**CITY OF PORTLAND, MAINE
DEVELOPMENT REVIEW APPLICATION
PLANNING DEPARTMENT PROCESSING FORM**

True Street Subdivision Project Name/Description

41 - 41 True St, Portland, Maine

True Street Subdivision
12.01.09

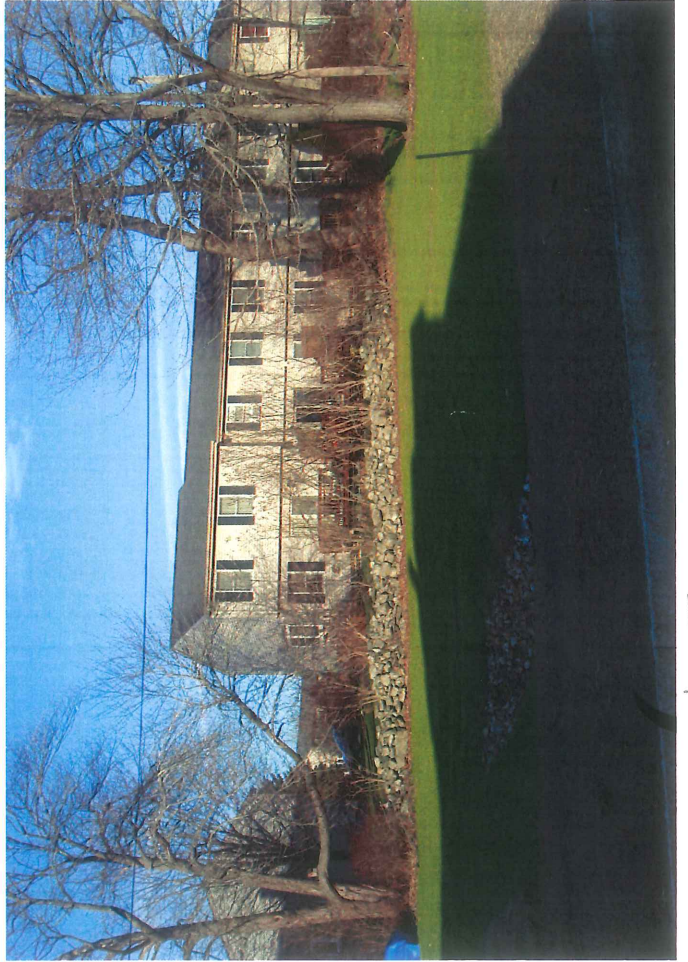
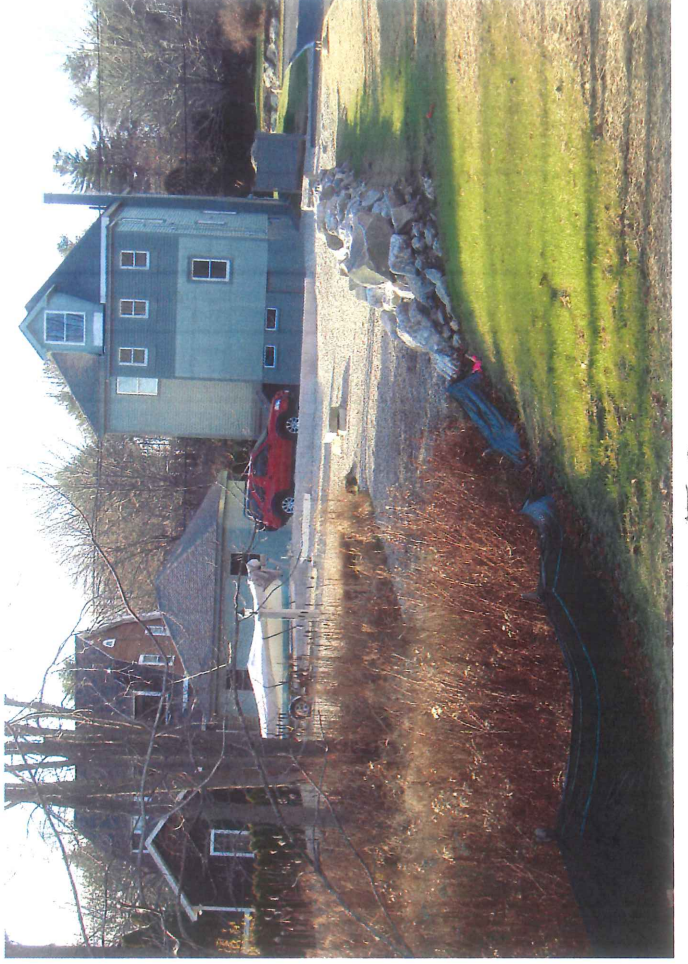
We fully intend to preserve the wetlands on our property per the plan. We have recently placed gravel not directly on the wetlands to encourage flow toward the pond & wetlands. Next Spring we will loam over it completely.

We plan to replace the Arborvitae on the Ocean Ave. side of our property and continue the Arborvitae row around the corner of Ocean and True. We would like to plant two Dawn Redwoods along the True Street side of our property instead of one redwood and one maple per the plan.

We would request that the proposed buffer trees not be planted at the back of the Sniper lot until a house is built on that property.

Attached is a PDF of the landscape plan with additional information about what trees we saved and what we proposed.

The street tree requirement has been met on lots 1, 2, 3, 4, 5, 6, 7 with existing trees. The plan proposed new street trees on lots 4 and 7 which will need to be installed if the existing trees are removed when the lots are developed.

We propose planting two Dawn Redwoods on lot 8 next spring to meet the street tree requirements. We will also plant a maple tree as a replacement on lot 2 for one that had to be removed.

We are requesting for the buffer trees on lot 2 & lot 7 not be planted until the lots are developed. There are already trees acting as buffer that have not been removed and the lot 7 abutter requests these not be planted until lot is developed. I am faxing to you the letter they are mailing to you.

- Trees Saved per plan
- Saved Additional Existing Trees
- New trees per plan to be planted Spring 2010 in modified locations
- Trees proposed to be planted Spring 2010

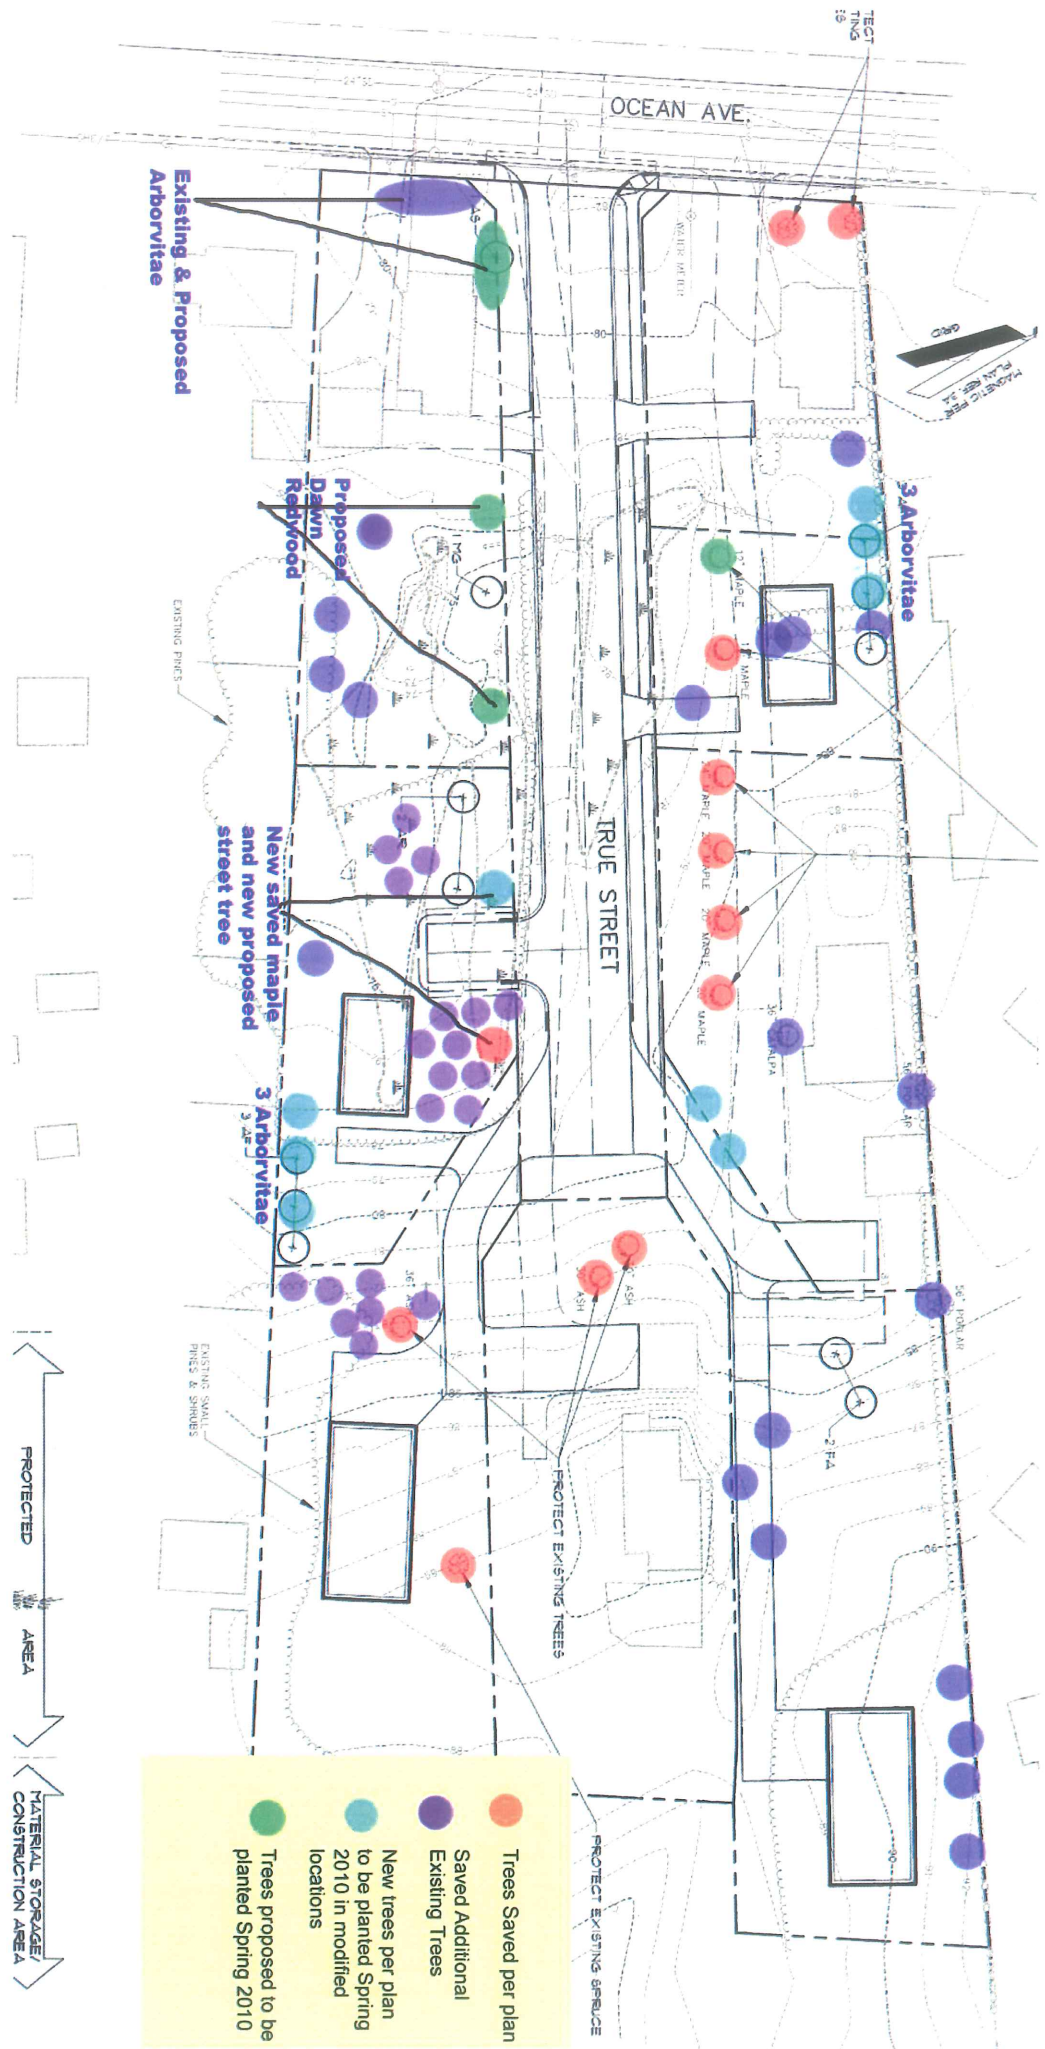
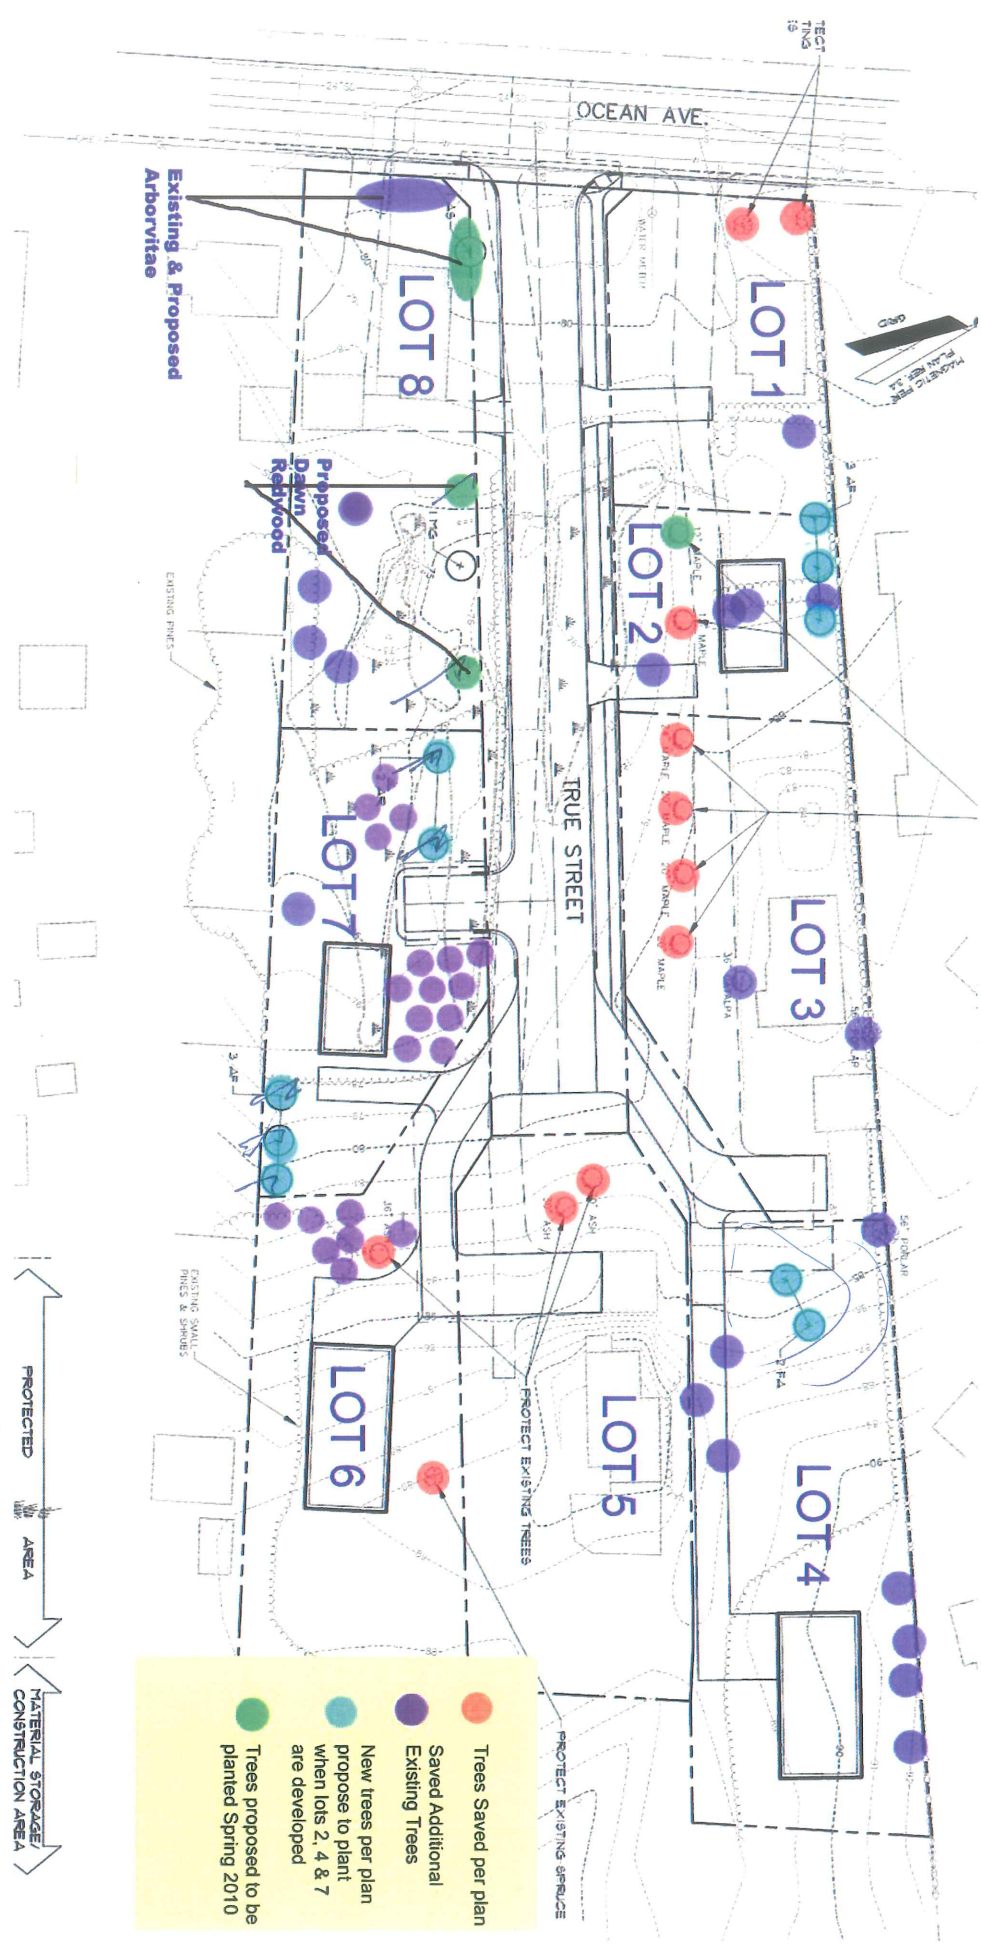
I reviewed the latest tree planting / landscape plan for the True Street project and find this acceptable as presented. Tree planting should be in place by the end of June in the Spring.

The Planning Division had reviewed and approved the attached revised landscaping plan. A condition of approval would be that the tree plantings shall be in place by the end of June 2010.
